Beauly to Blackhillock to New Deer to Peterhead 400kV Overhead Line

Summary Report on Consultation

January 2025

Alignment Section 12: Cairn Duhie to Johnstrie

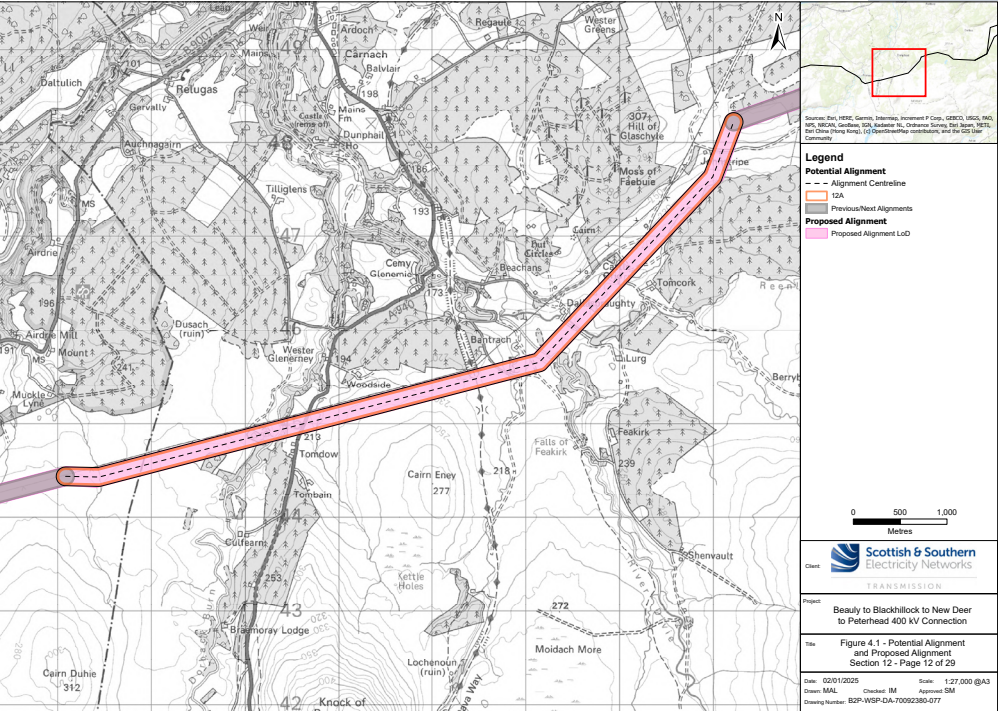
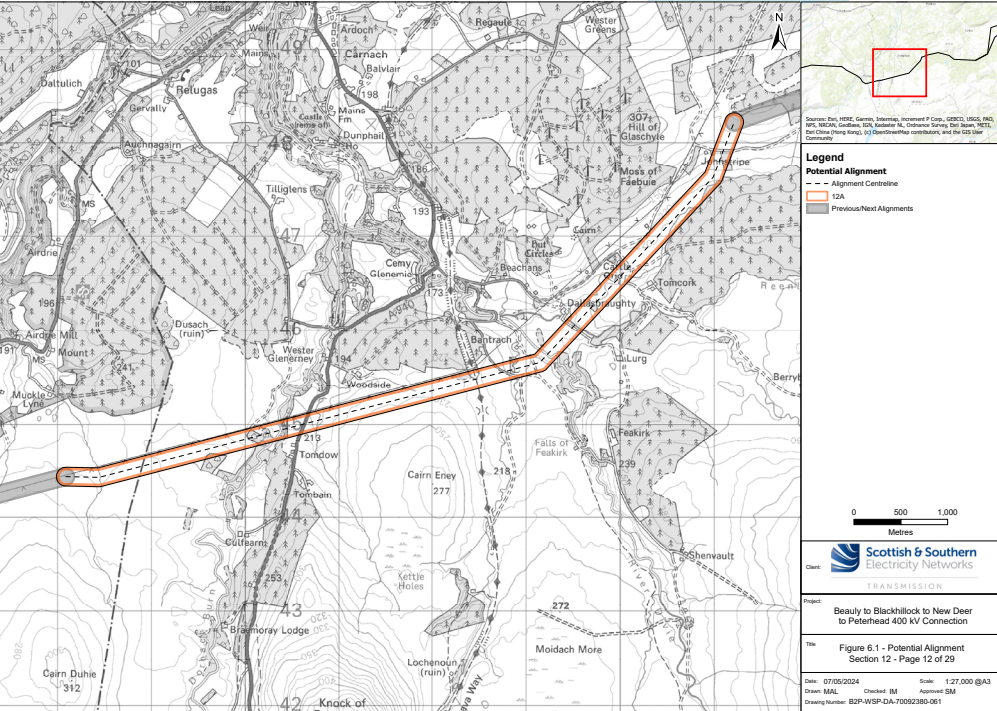
Within Alignment Section 12 concerns were raised about potential impacts to historical sites, such as Dunphail House and Castle.

Historic Environment Scotland recommended the preparation of visualisations to further inform the assessment of cultural heritage designations and assets within Alignment Section 12.

The potential for impacts on Dunphail House and Castle have been considered throughout the routing and design process. The Proposed Alignment has been selected and designed to minimise the impacts on the house, with the result that there is limited to no visibility of the towers from the house.

No changes have been made to Potential Alignment 12A and this will be taken forward as the Proposed Alignment, as it is the least constrained option from both an environmental and engineering perspective and is also the lowest capital cost option.

Alignment Section 15: Glenlatterach Reservoir to Glen of Rothes

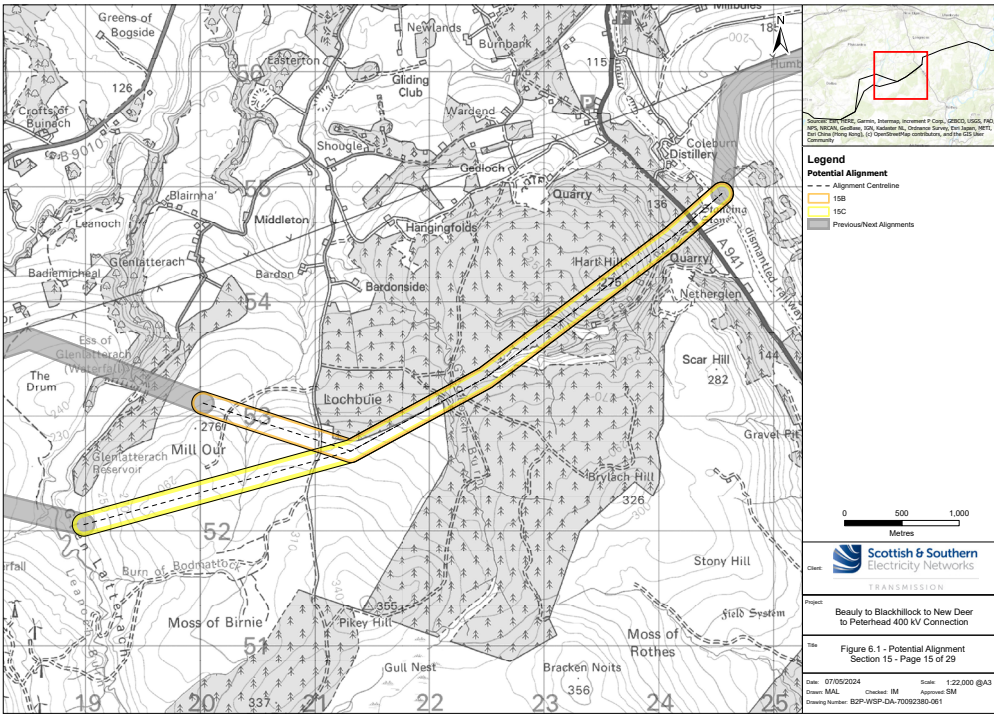
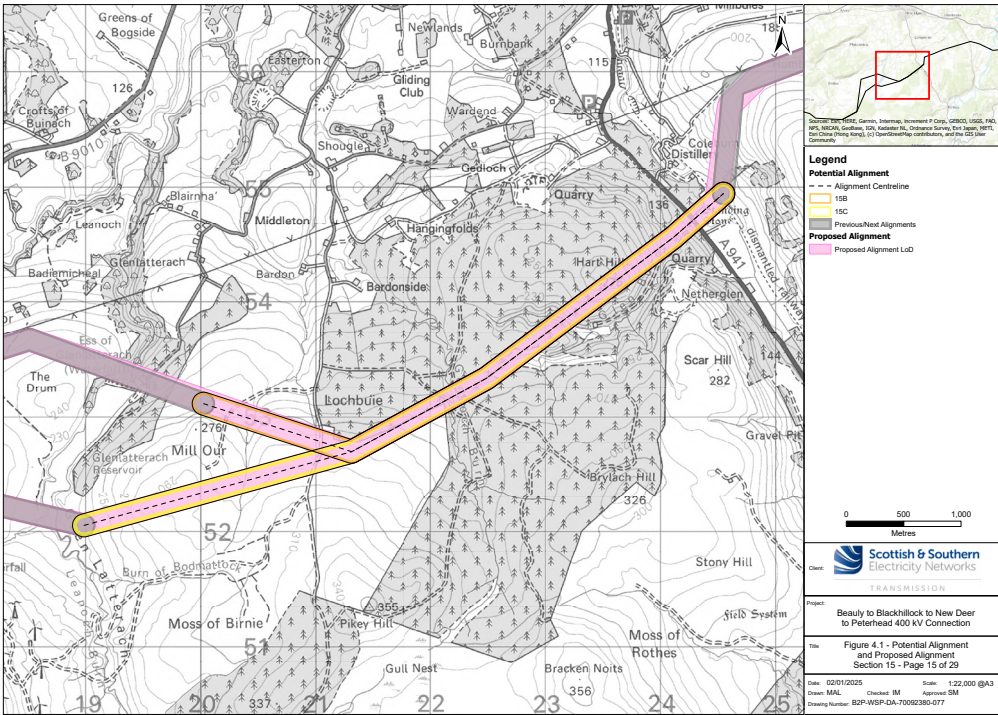
In Section 15 concerns were raised about potential impacts to public walking routes and the Highland Gliding Club.

Scottish Water raised concerns about potential impacts on Glenlatterach reservoir, which supplies Glenlatterach Water Treatment Works.

Consultation with Scottish Water and NatureScot is ongoing to agree mitigations to minimise potential impacts to Glenlatterach reservoir and Coleburn Pastures SSSI.

Discussions have been ongoing with the Highland Gliding Club and it is understood that the club would be impacted by the Proposed Alignment however due to surrounding residential and topographical constraints any movement of the alignment in this area is very constrained. Further discussions will continue to take place through the detailed design stage.

Potential Alignments 15B and 16A have been refined slightly due to minor changes to angle tower positions following engineering surveys.

No changes have been made to Potential Alignment 15C as any movement of the alignment in this area is very constrained due to surrounding residential and topographical constraints.

Alignment Section 16: Glen of Rothes to Teindland

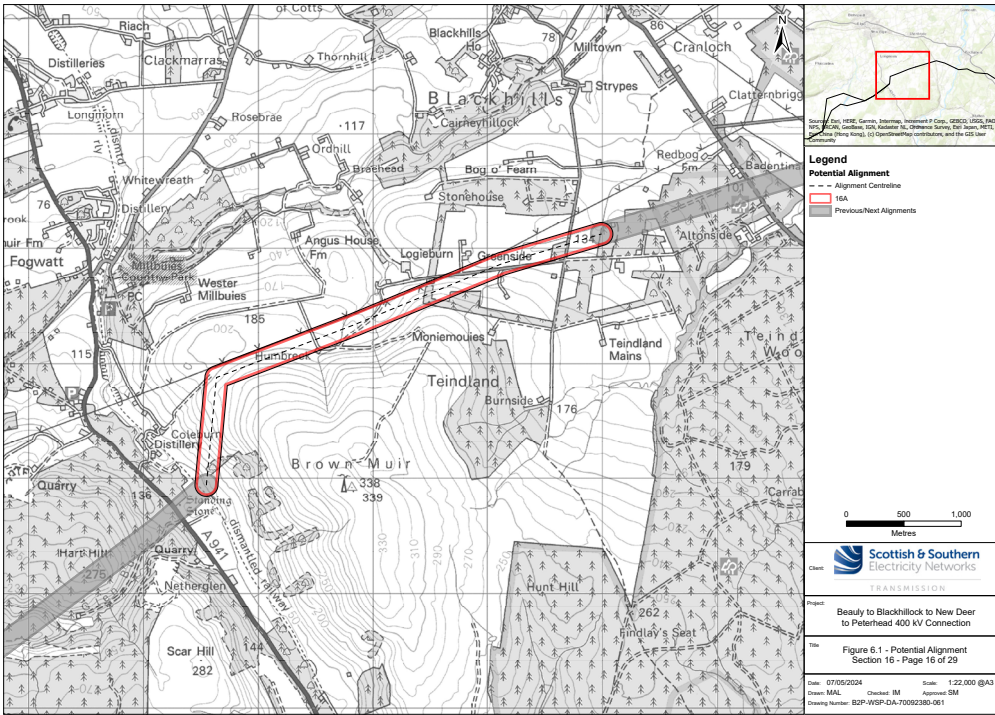
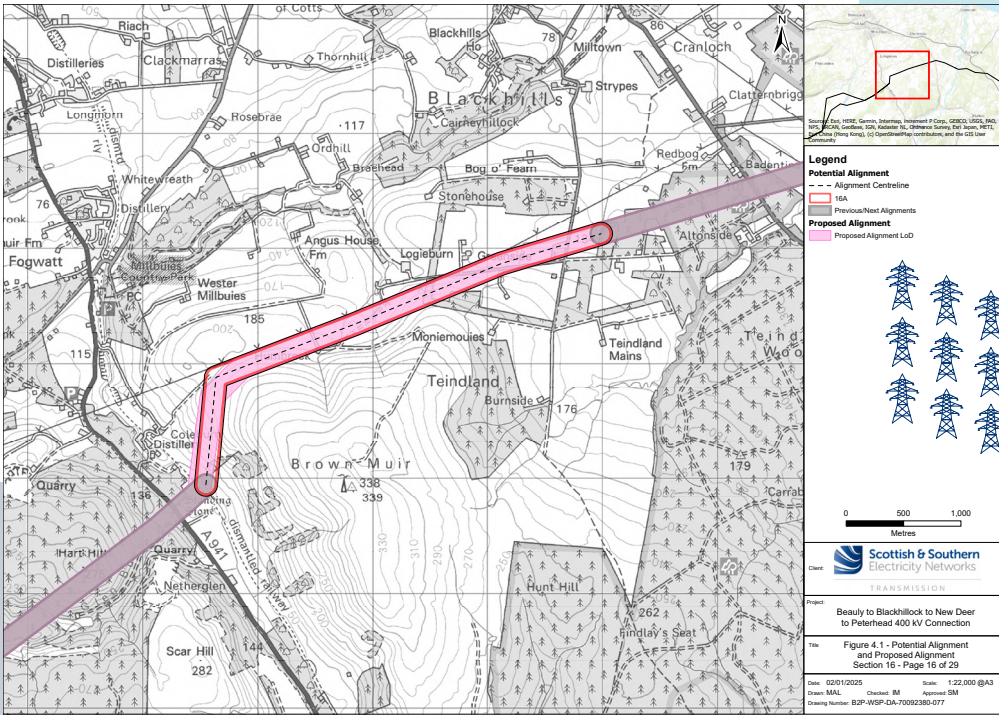
In Section 16 Moray Council highlighted that the Potential Alignment is near to Blackhills House Gardens and Designed Landscapes (GDL) and NatureScot noted Coleburn Pastures SSSI is close to the Potential Alignment and will require careful consideration.

Historic Environment Scotland (HES) requested visualisations of Blackhills House and Bogton Stone Circle to be included as part of the cultural heritage assessment.

Alignment Section 25: Burn of Turriff to Greens Substation

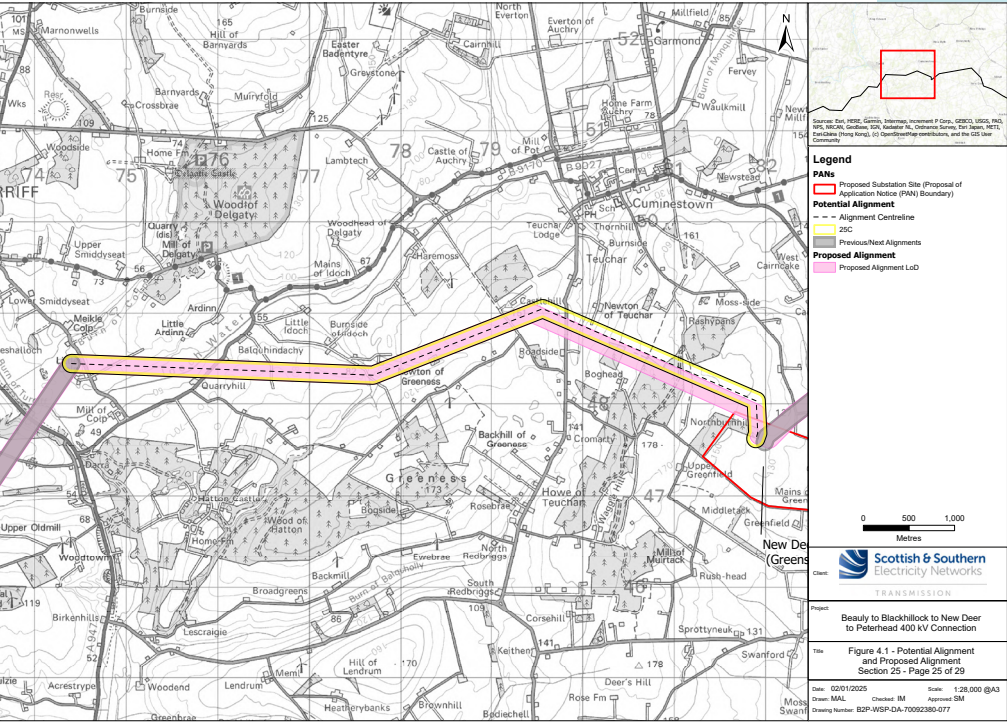
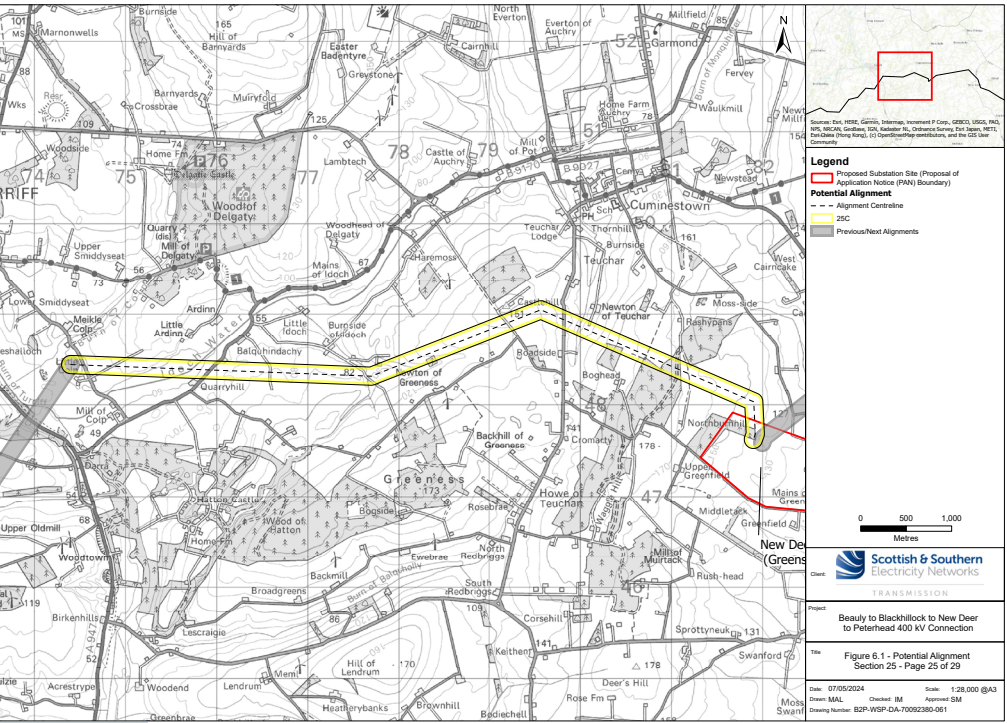
In Section 25 concerns were raised around impacts of the Proposed Development on people living nearby who have sensory issues. Requests were also made to move the alignment to accommodate future potential development and to more closely follow field margins to minimise impacts on land use.

Historic Environment Scotland (HES) recommended further assessment be conducted on the cultural heritage designations and assets in Section 25, requesting visualisations to accompany the consent submission.

Queries were raised in relation to how we intended to protect wild salmon and sea trout and ensure habitats would not be diminished both during construction and operational stages.

Feedback was provided on a popular walking trail outside Cuminestown, where a tower was indicated as being situated right on the edge of the walking path.

We understand there will be concerns around the construction and operation of the Proposed Development, especially where there are particular sensitivities within households. We would encourage anyone with concerns to inform us of this, so that we can work closely with affected households to minimise, where possible, any impact and ensure sufficient notice is provided ahead of any works.

HES comments will be taken on board and visualisations are being prepared as part of the cultural heritage assessment within the EIA report.

Further assessment will be carried out to understand the potential for impacts on the aquatic and riparian habitats, and any mitigation required. The Construction Environmental Management Plan will set out how works will comply with mitigation measures and industry best practice. This will then be overseen during the construction phase by a suitably qualified and experience Environmental Clerk of Works (ECOW), with support from other environmental professionals as required. Once operational, regular inspections are undertaken of the OHL and towers which would highlight any deterioration which may impact the environment.

The Proposed Alignment has been moved slightly further south than Potential Alignment 25C at the eastern end, to be closer to field margins and reduce limitations to future land use.

The Proposed Alignment has also been moved further from the footpath.
